**RE: 5304 Granite Ave NE
Grading & Drainage Plan
Engineer's Stamp Date: 9/25/25
Hydrology File: J17D042
Case # HYDR-2025-00344**

Based upon the information provided in your submittal received 9/25/2025, the Grading & Drainage Plan is approved for Building Permit. Please attach a copy of this approved plan in the construction sets for Building Permit processing along with a copy of this letter.

LOT 3, BLOCK 16
ALBUQUERQUE HIGHLANDS ADDITION
GALANTER (ADWELLING) - GRADING & DRAINAGE PLAN
McDowell Engineering, Inc.
7820 BEVERLY HILLS AVE. NE • ALBUQUERQUE, NM 87122
TELE: 505-828-2430 • FAX: 505-821-4857
Designed JSM Drawn STAFF Checked JSM Sheet 1 of 1
File GAL0125L Date JULY,2025

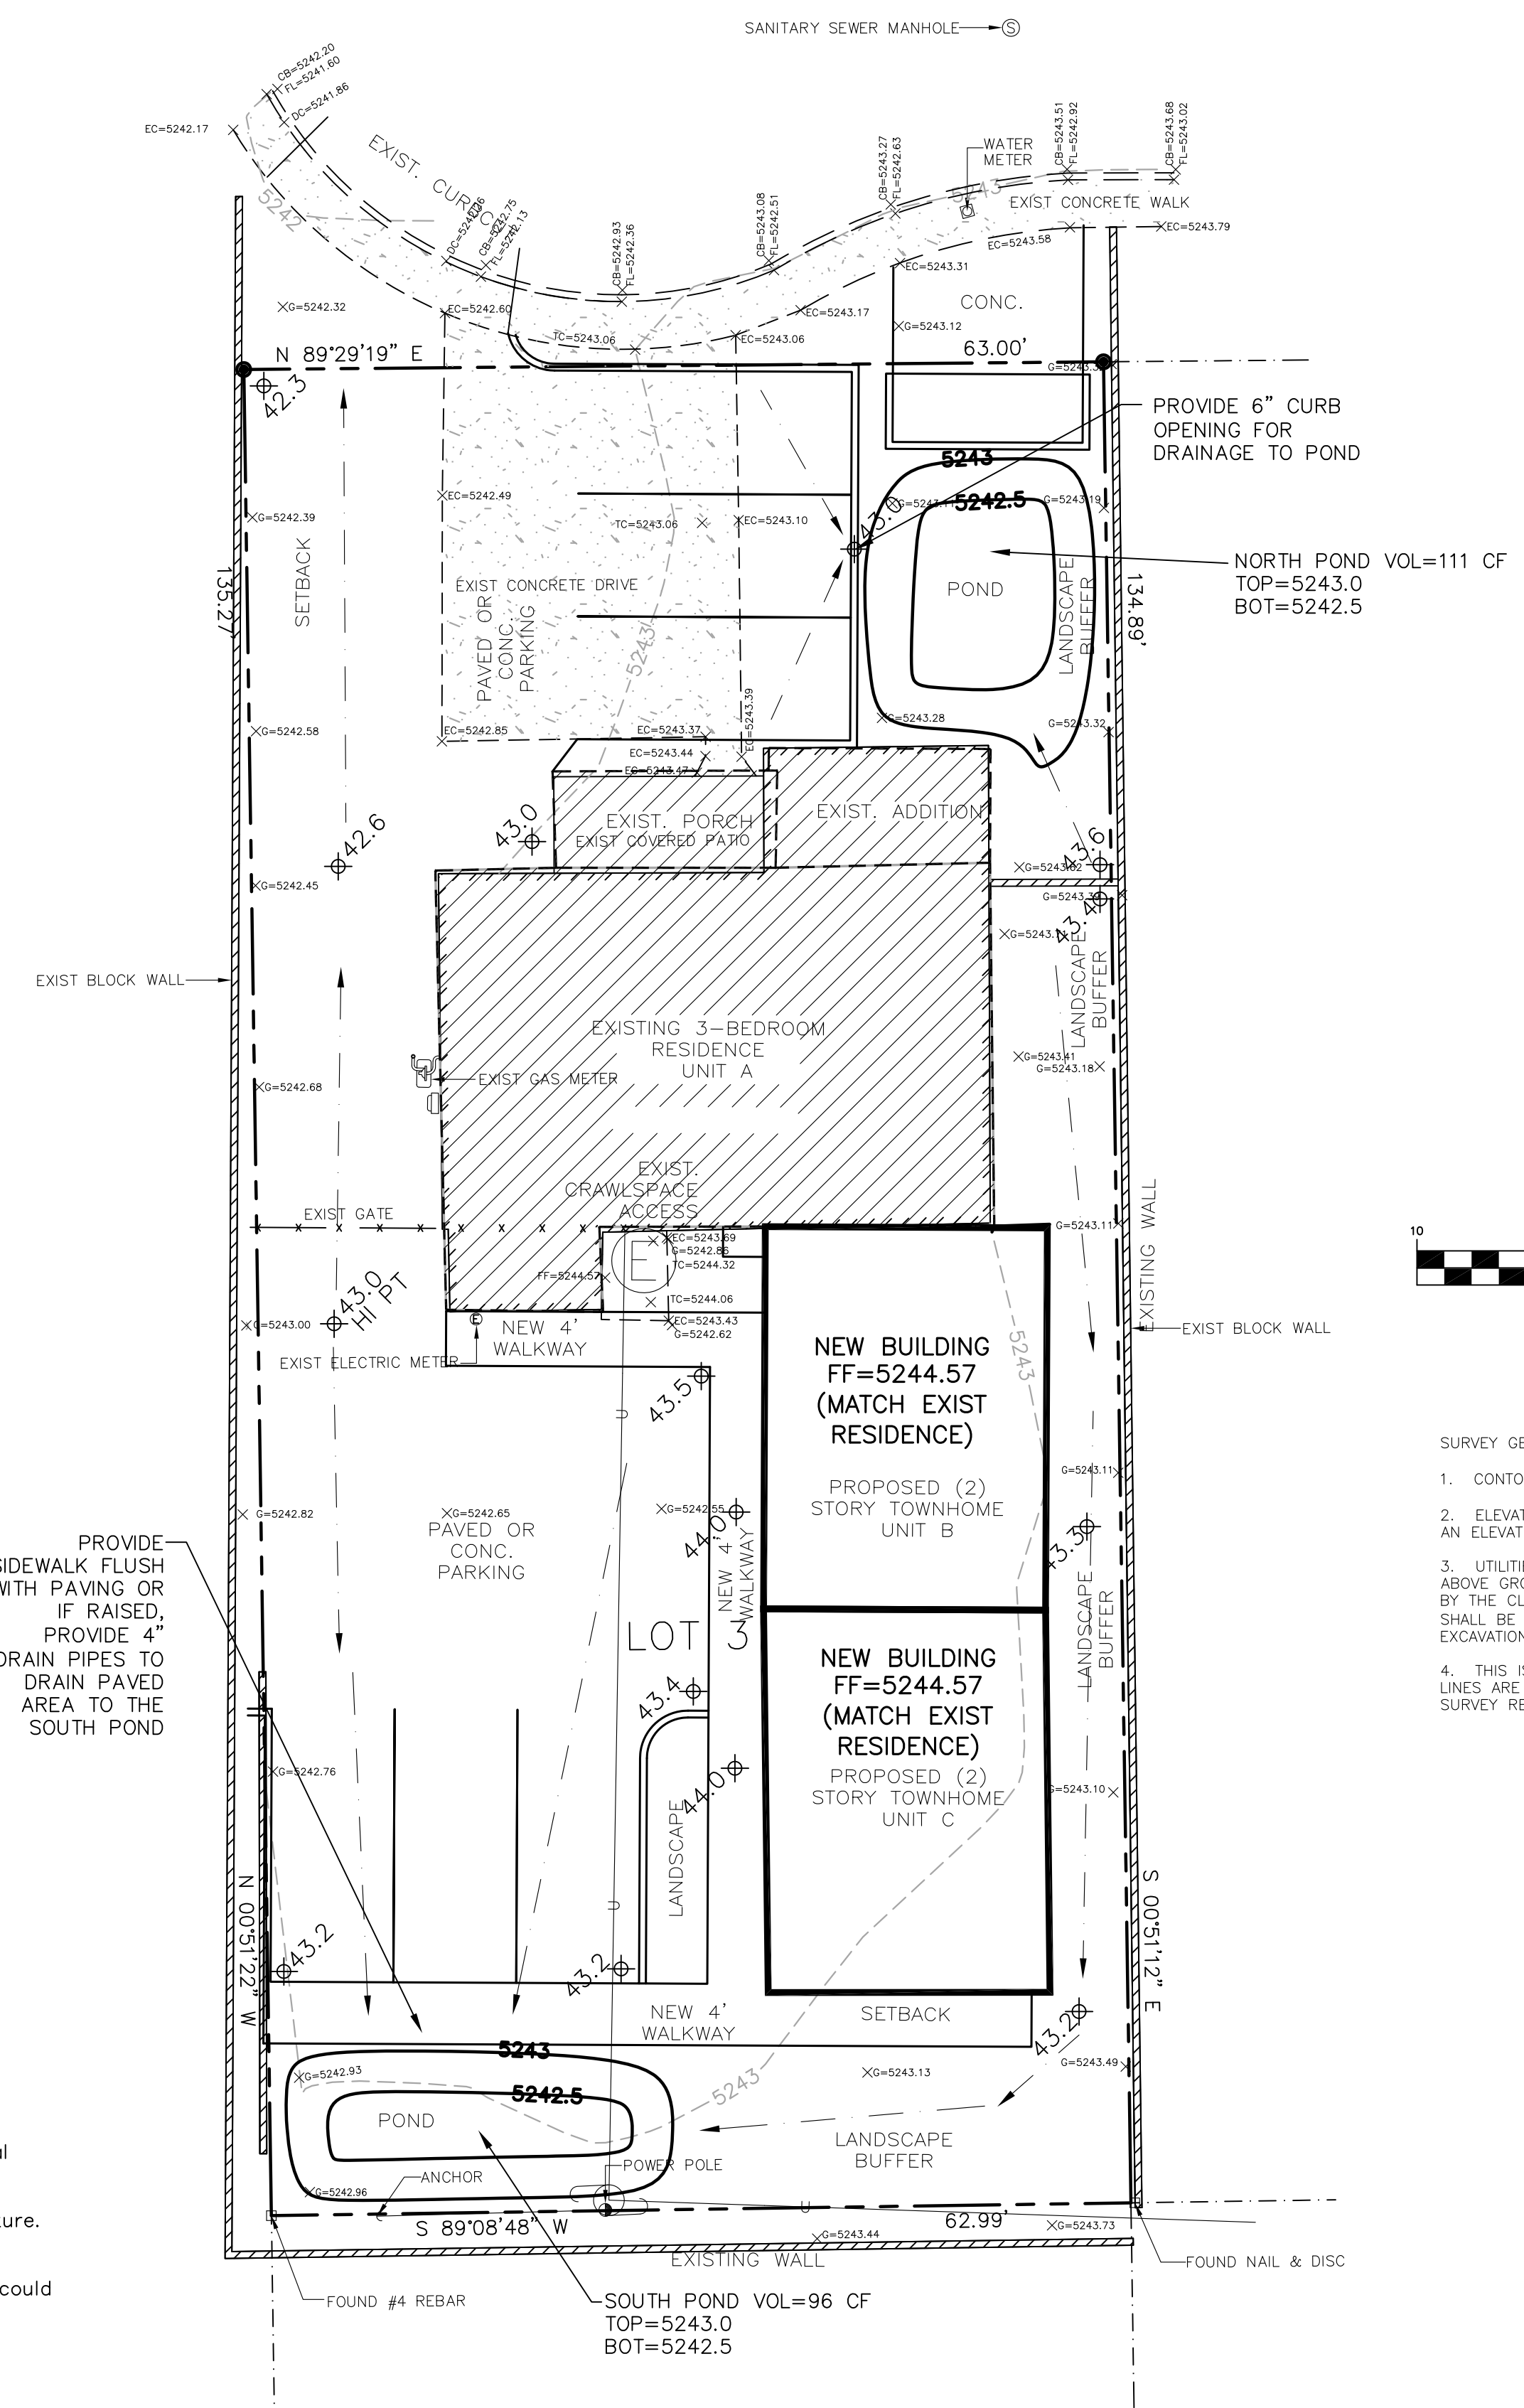
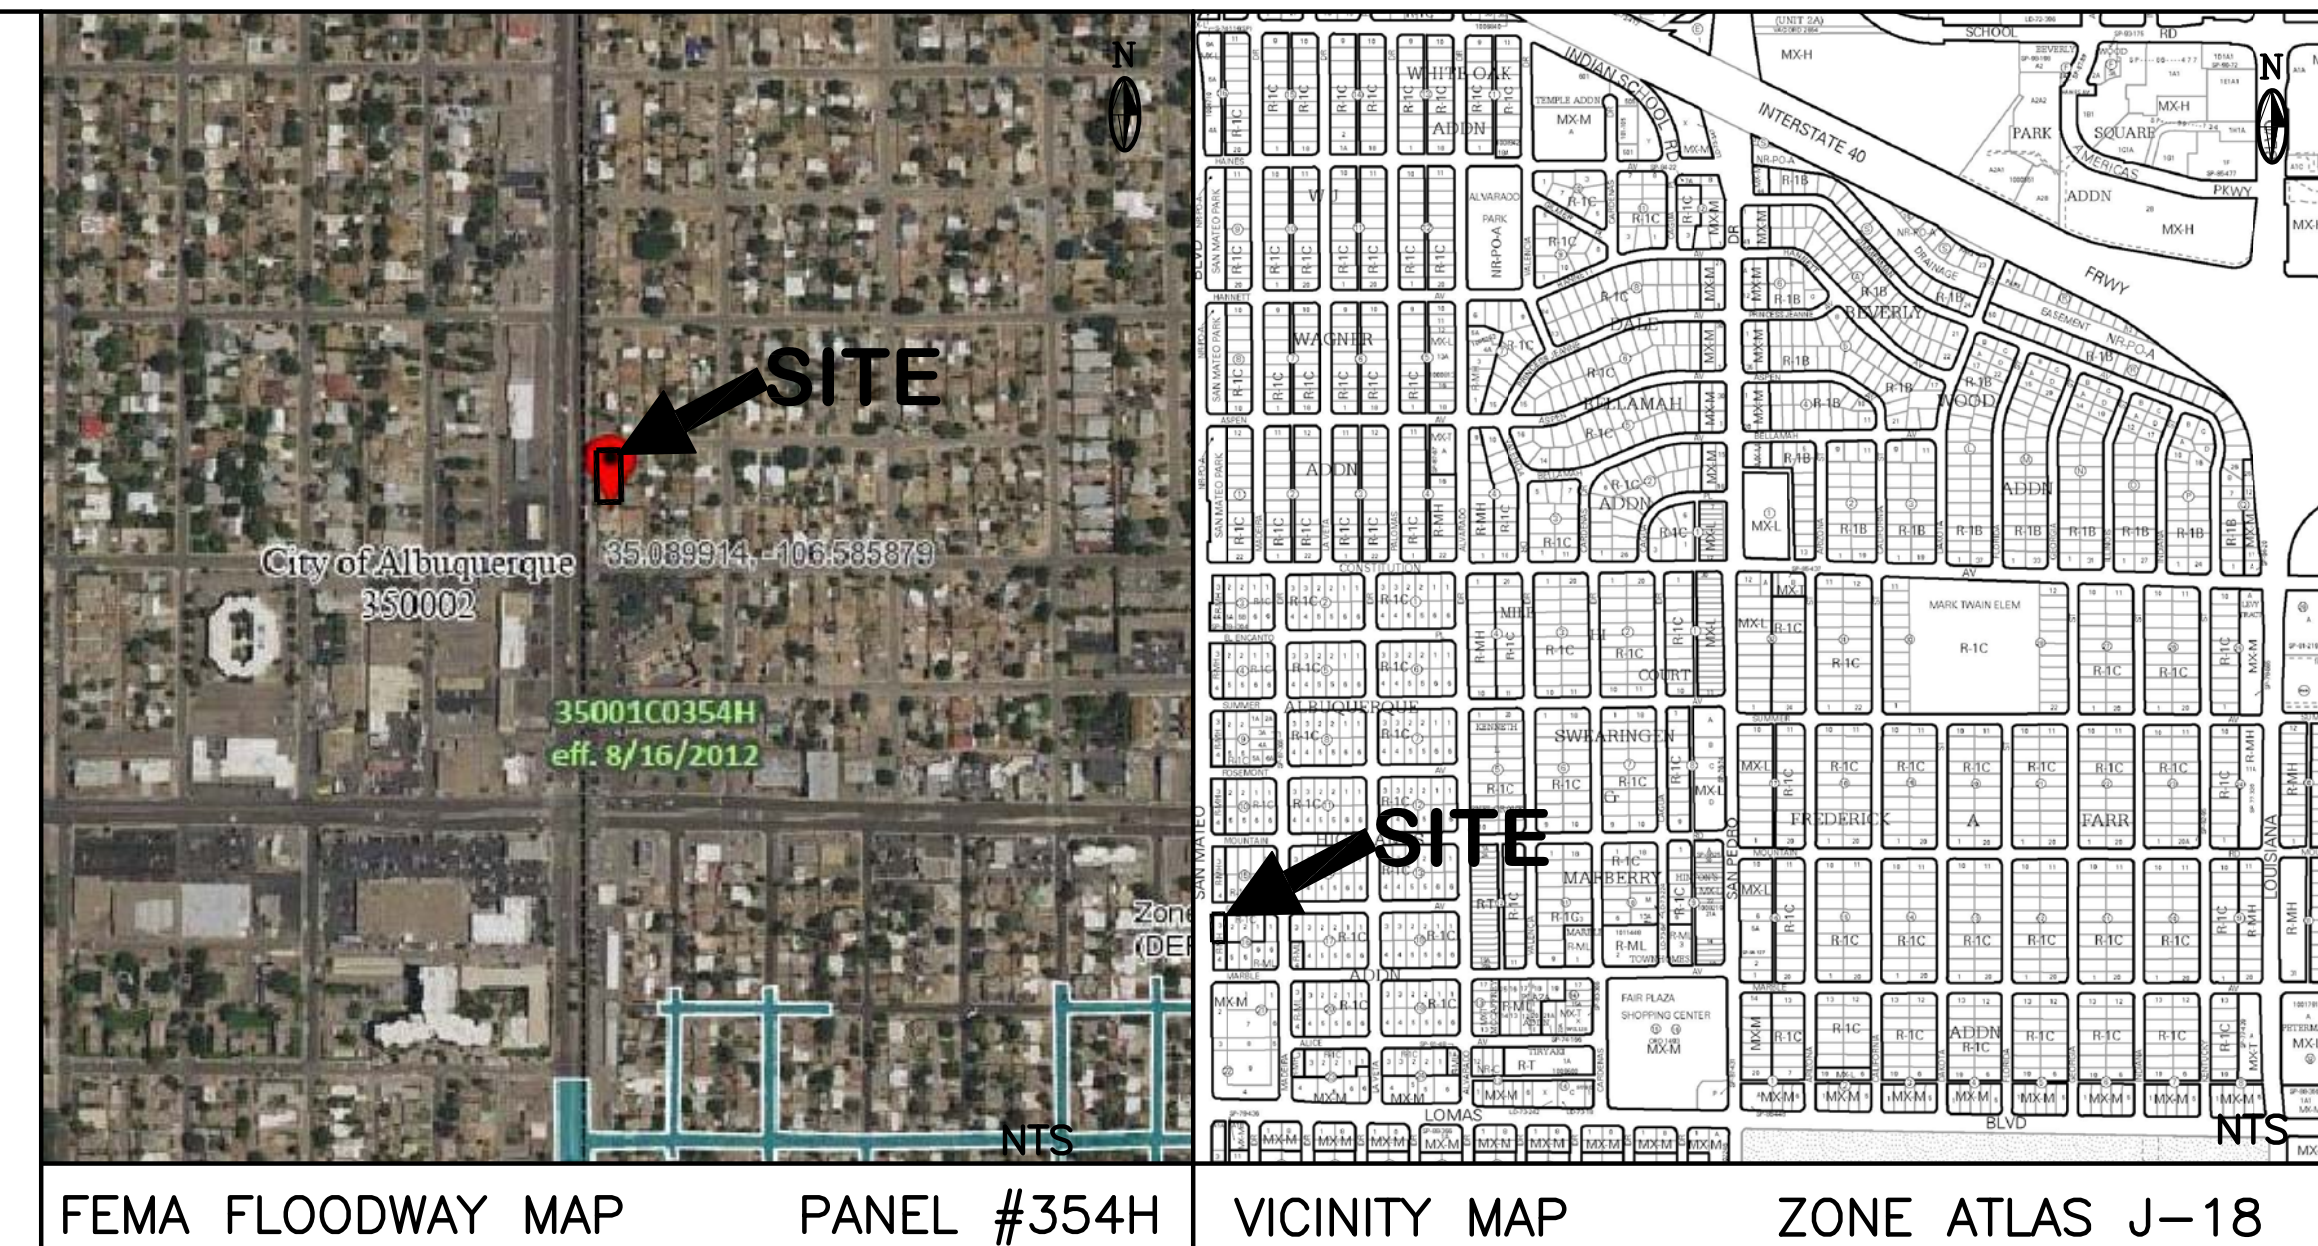
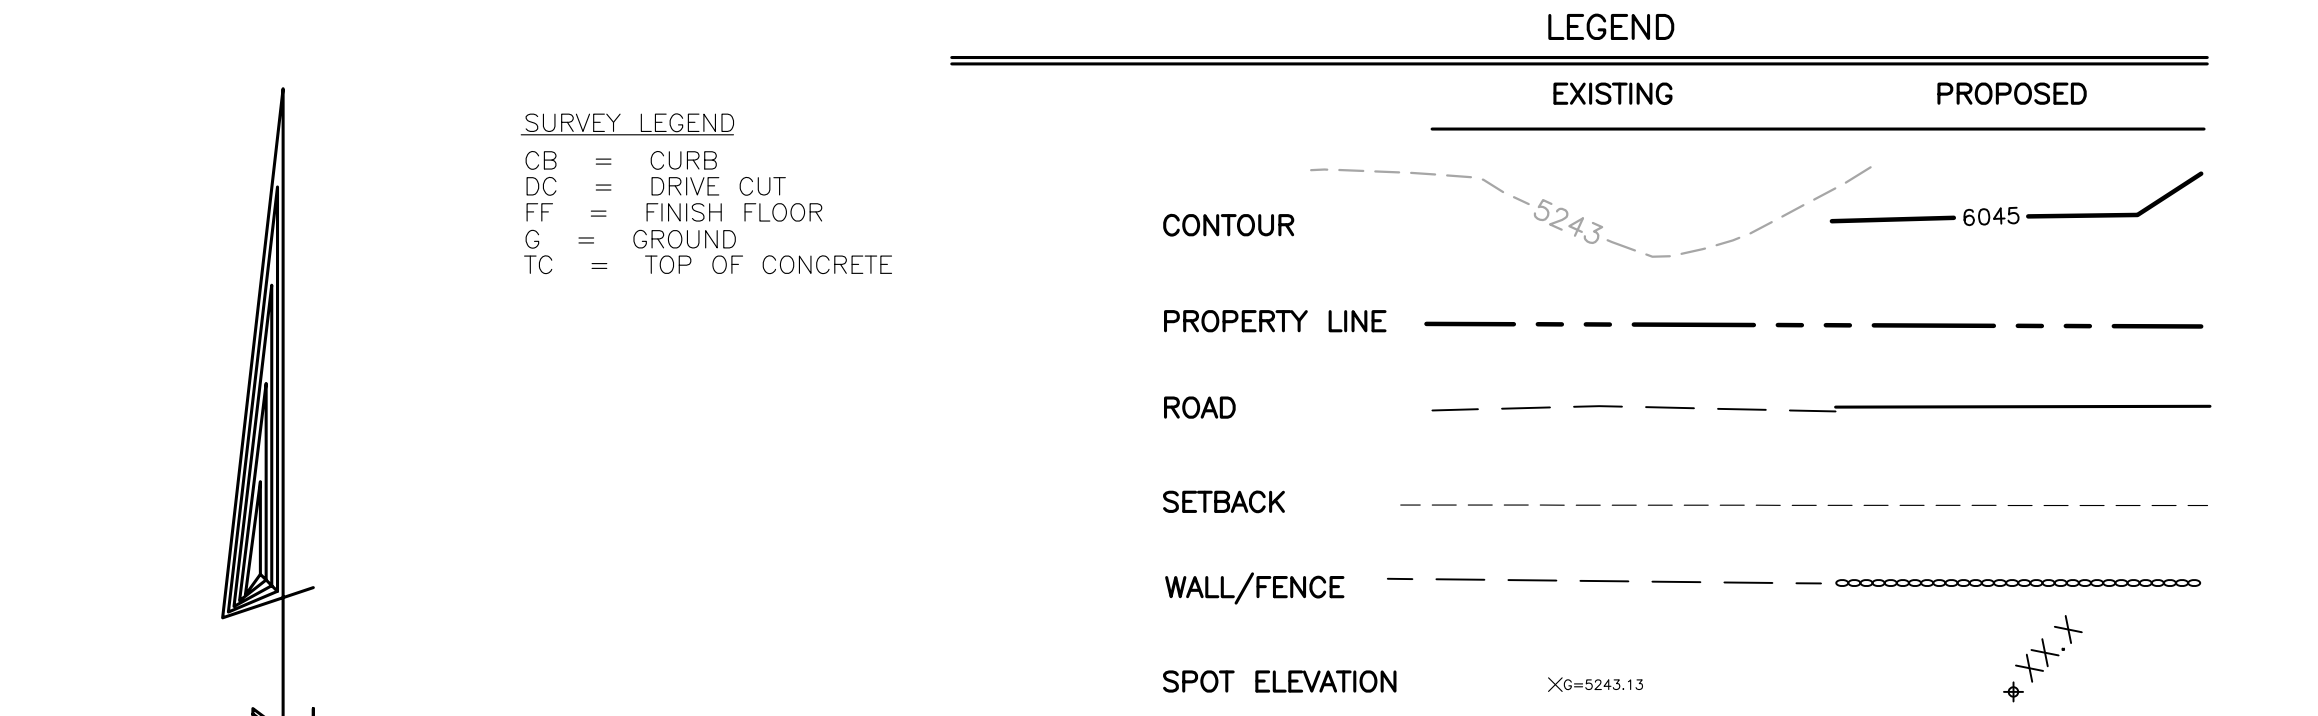
1. Engineer's Certification, per the DPM Part 6-14 (F): *Engineer's Certification Checklist For Non-Subdivision* is required.
